1.1 Basement Floor Plan Zones 2-5 - Demolition drawings

The following drawings show the amended extent of demolition at Basement Level Zones 2-5 Gridlines W1-W26 of The Western Range Building:

Job Title
 King's Cross Station
 Redevelopment Programme
 Package 6

Scale at A1
 1:100
 CCM6 No
 Drawing Status
For Construction
 CAG Job No
123345-00 Drawing No
WRB-CAP-0023 Rev
07

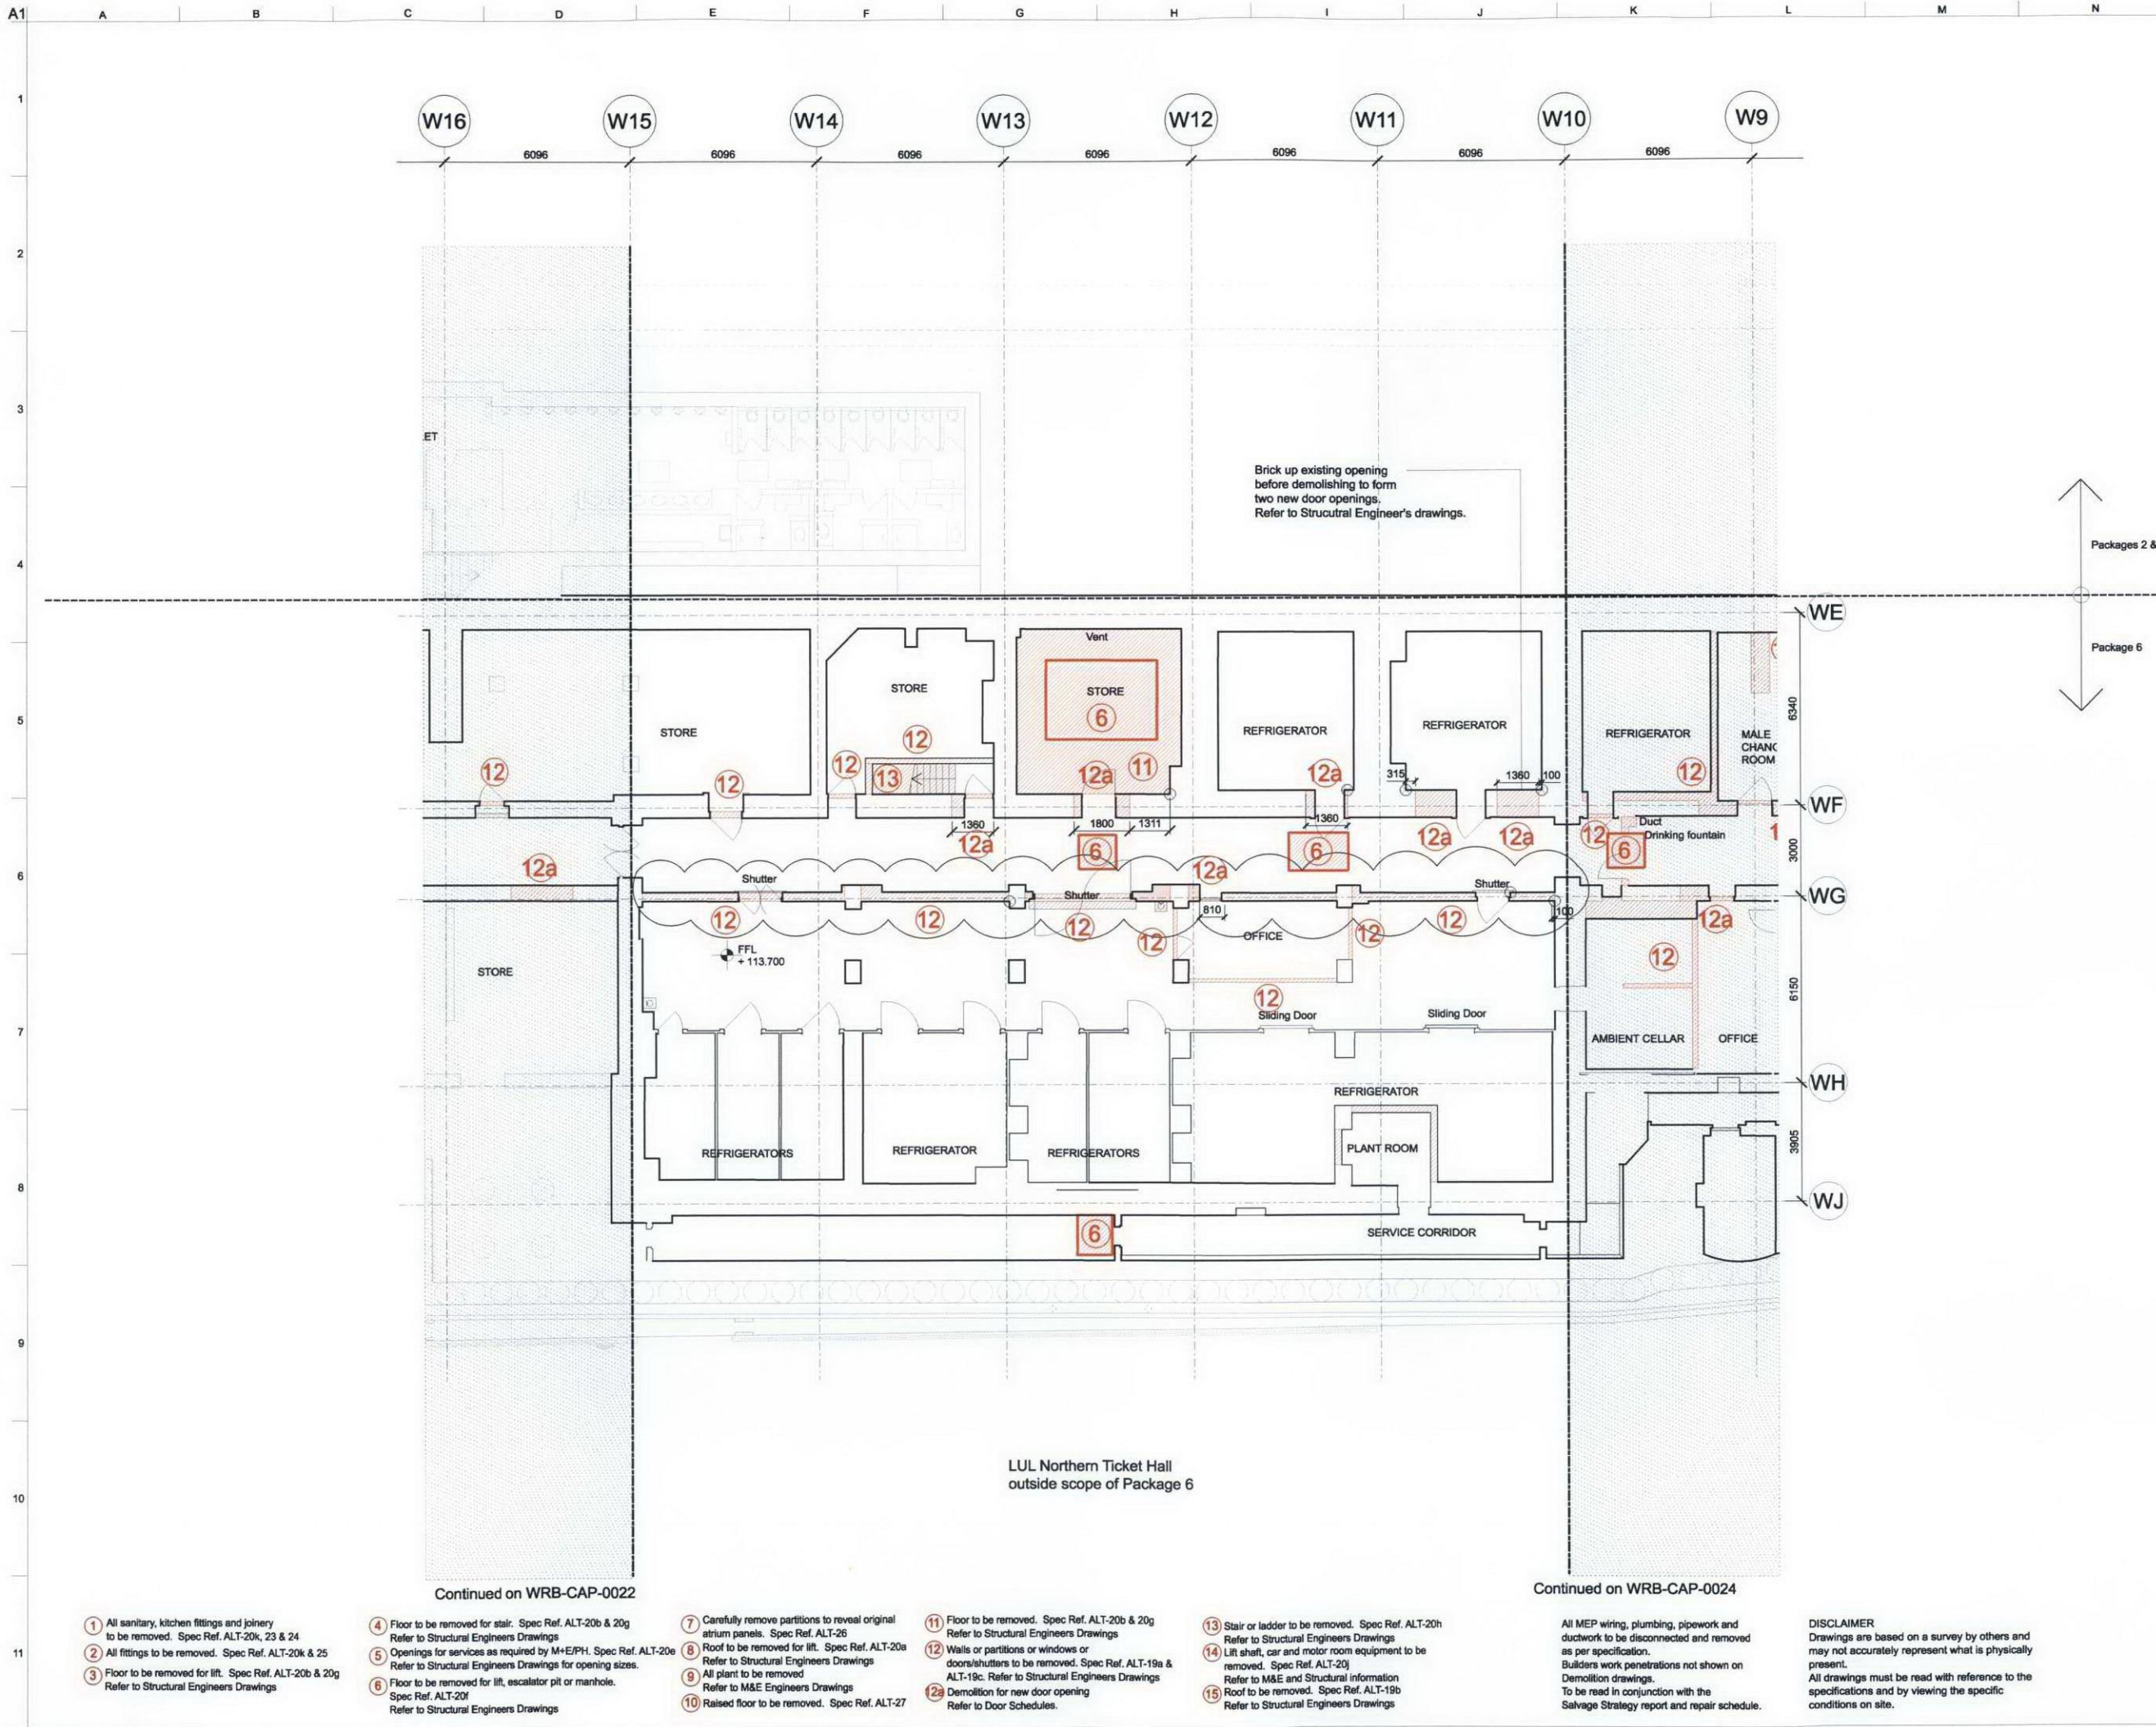
07	23/04/10	JMP	FS	AD
Revised in relation to CCRF 0084				
06	07/08/09	JMP	GM	AD
Updated in accordance with workshop review records KX6P-PAW-SH-0027 & KX-PAW-SH-00023.				
05	15/05/09	JMP	GM	AD
Post Value Management coordination issue				
04	31/01/09	JMP	SS	AD
Revised in accordance with GRIP 6 Value management redesign scope				
03	20/06/08	KM	CD	AD
For GRIP 5B Production Information Door opening to be widened as noted				
02	29/02/08	JMP	AD	MC
For GRIP 5B Production Information				
01	07/12/07	GM	SS	MC
Issued for GRIP Stage 5A

For Construction
 GMP Job No: 123345-00
 Drawing No: WRB-CAP-0024
 Rev: 07

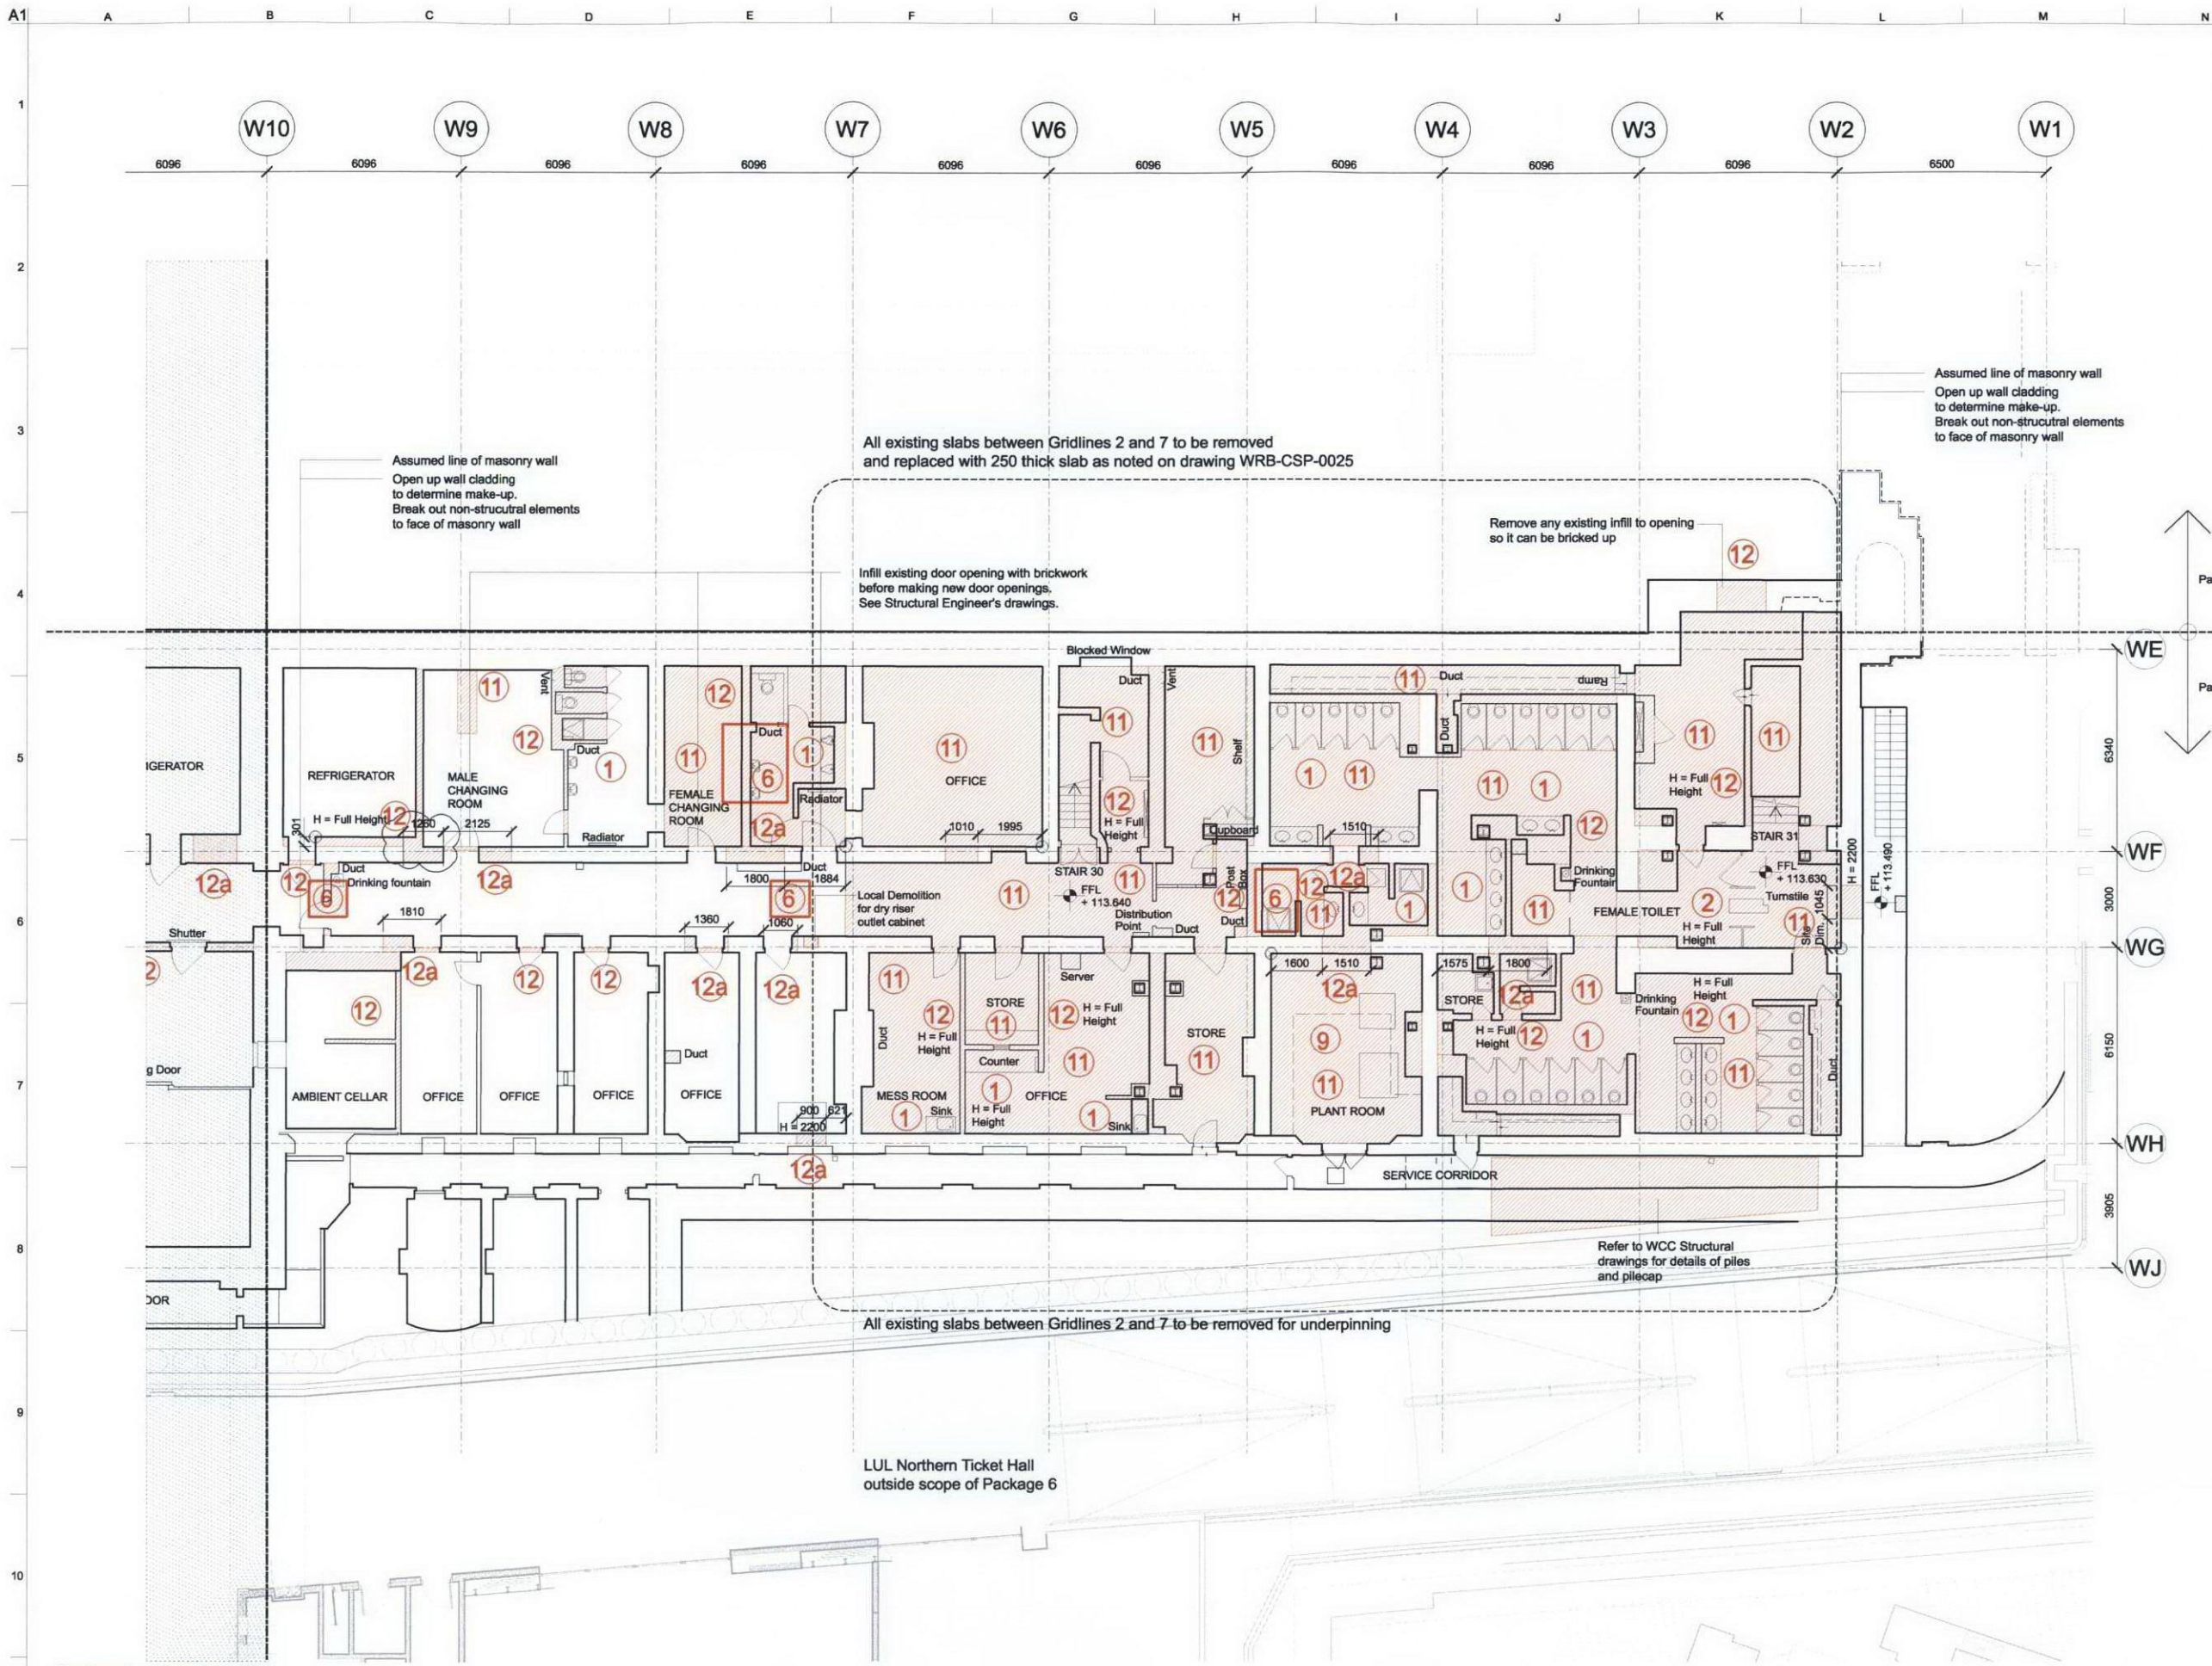
07	23/04/10	JMP	FS	AD
Revised in relation to CCRF 0084				
06	07/08/09	JMP	GM	AD
Updated in accordance with workshop review records KXBP-PAW-SH-0027 & KXBP-PAW-SH-00023				
05	15/05/09	JMP	GM	AD
Post Value Management coordination issue				
04	31/01/09	JMP	SS	AD
Revised in accordance with GRIP 6 Value management redesign scope				
03	20/06/08	KM	CD	AD
For GRIP 5B Production Information Door openings to be widened as noted				
02	29/02/08	JMP	AD	MC
For GRIP 5B Production Information				
01	07/12/07	GM	SS	MC
Issued for GRIP Stage 5A
